Recall Bulletin

F/CMVSS NONCOMPLIANCE RECALL

SUBJECT: Heating and Windshield Defrost Inoperative – Replace Computer Module

MODELS: 2010 Chevrolet Equinox
2010 GMC Terrain

2244752

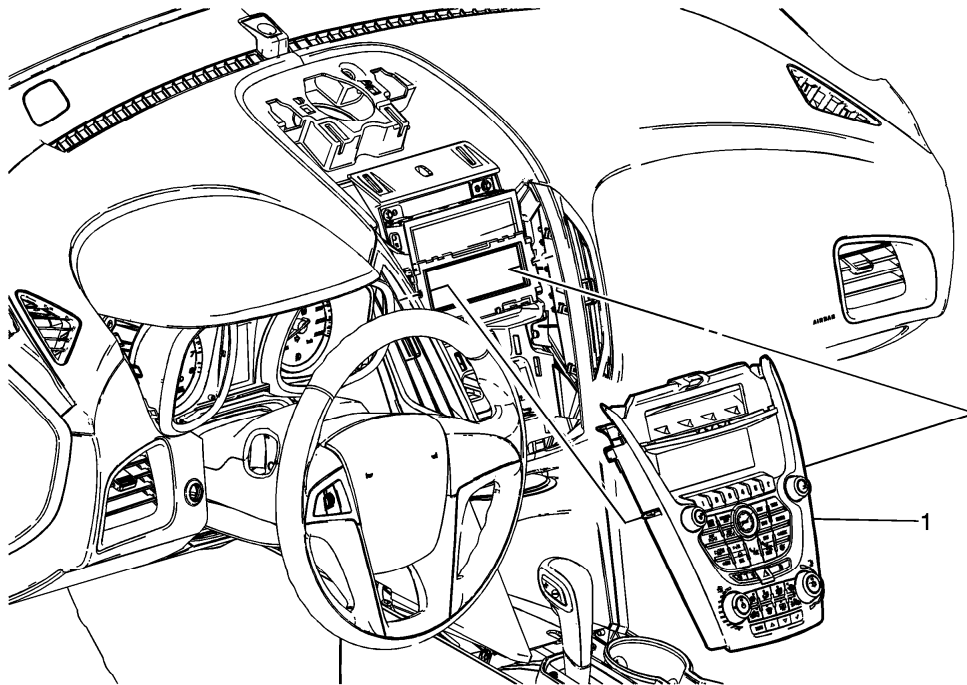
Note: For vehicles without the color touch screen navigation, unsnap and remove the display from the radio control assembly. Do not return the radio display with the radio control assembly.

1. Remove the radio control assembly (1). Refer to *Radio Control Assembly Replacement* in SI.
2. Package the radio control assembly and ship it to the exchange center indicated on the prepaid Federal Express overnight label that was enclosed with the exchange unit **within 24 hours**.

3. Install the radio control assembly. Refer to *Radio Control Assembly Replacement* in SI.
